Addendum 01

PROJECT: Antwerp Local Schools Bus Building Addition and Renovation
303 Harrmann Road
Antwerp, Ohio 45813

PROJECT #: 25057.00

SHEET NUMBER:
A3.1

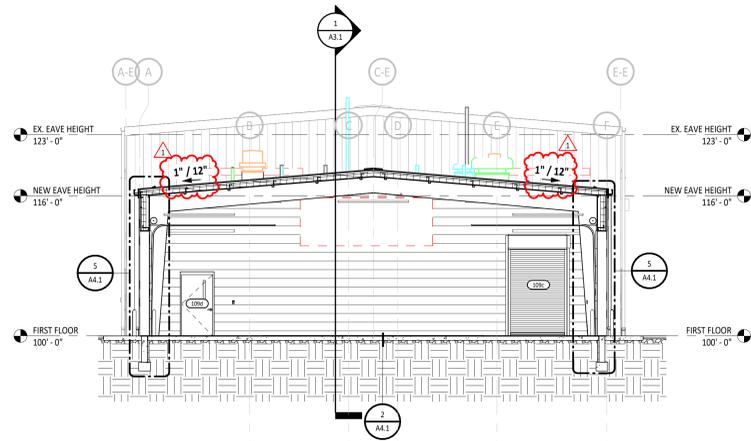
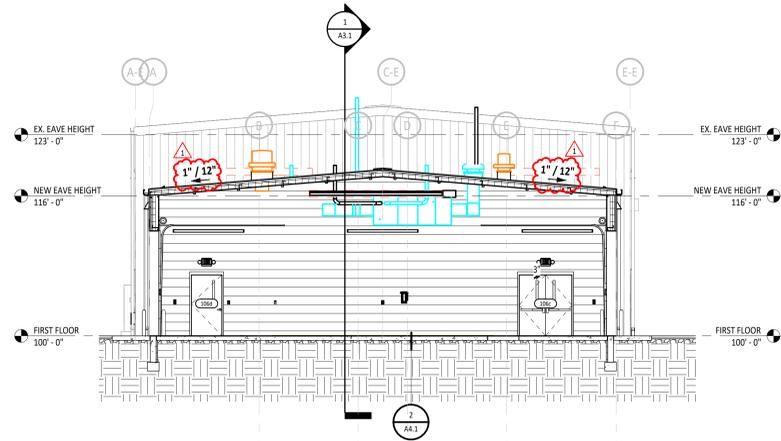
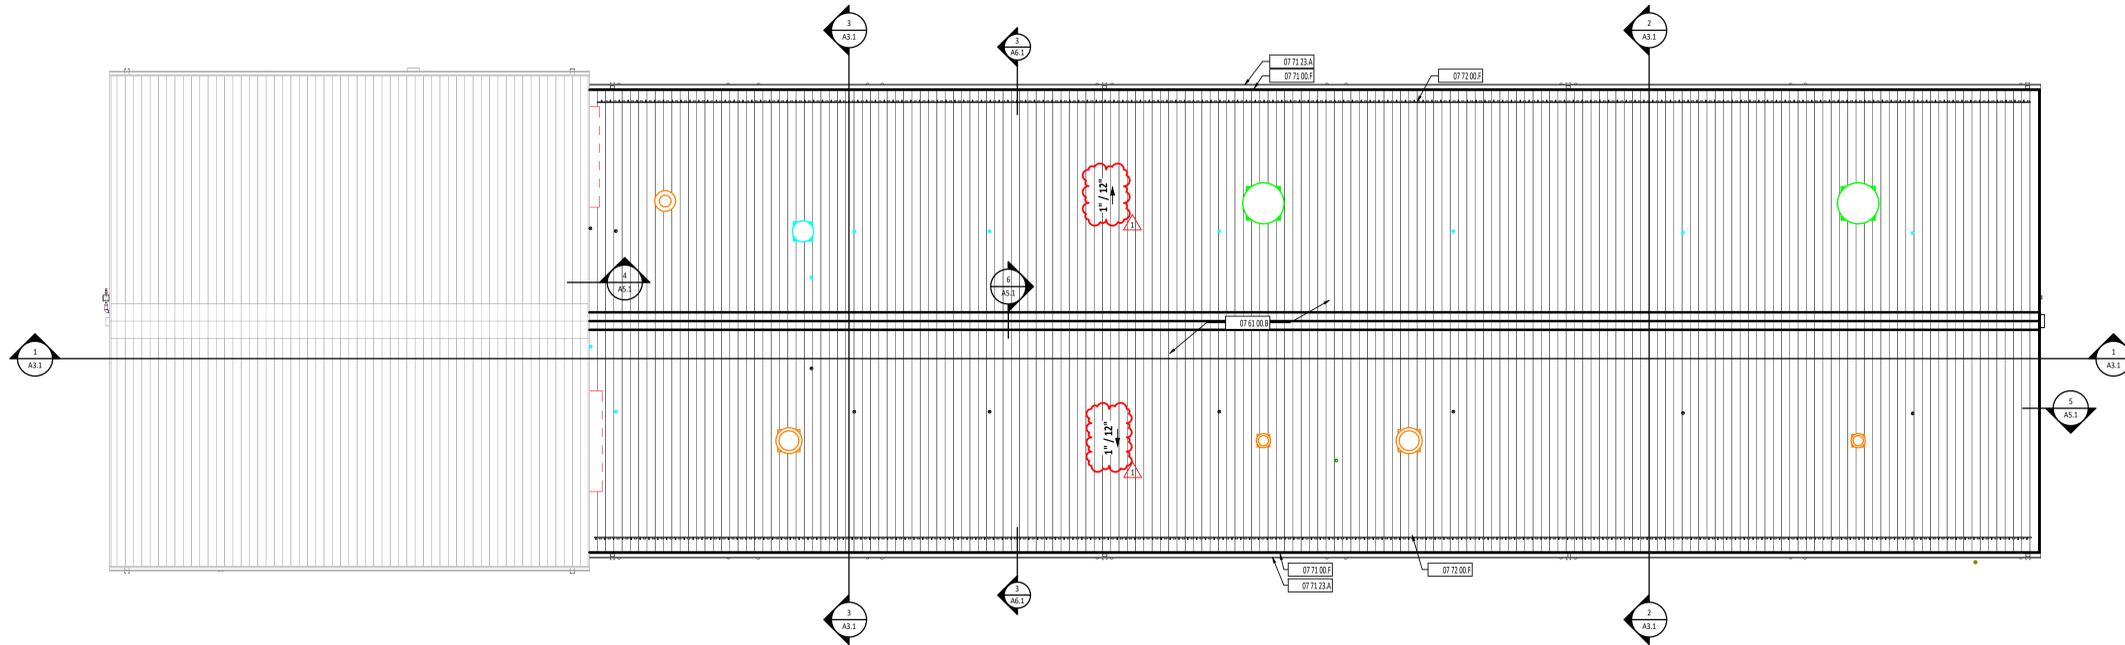
1. Drawing Sheet A1.1 First Floor Plan and Column Details
 - a. Add fire extinguishers to floor plan.
 - b. Adjust floor slab slopes.
2. Drawing Sheet A3.1 Building Sections
 - a. Add roof slopes to building sections
3. Drawing sheet A5.1 Roof Plan and Roof Details
 - a. Add roof slopes to roof plan

4 DOOR TYPES
A6.1 1/4" = 1'-0"

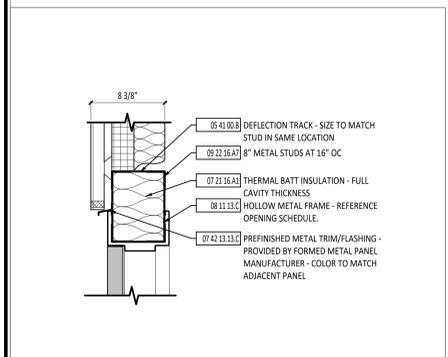
4. Drawing Sheet A6.1 Door Schedule and Details
 - a. Changes made to Door Schedule
 - i. Add glazing type to door 106c
 - ii. Add door hardware sets to all doors
 - iii. Switching overhead doors from aluminum to steel
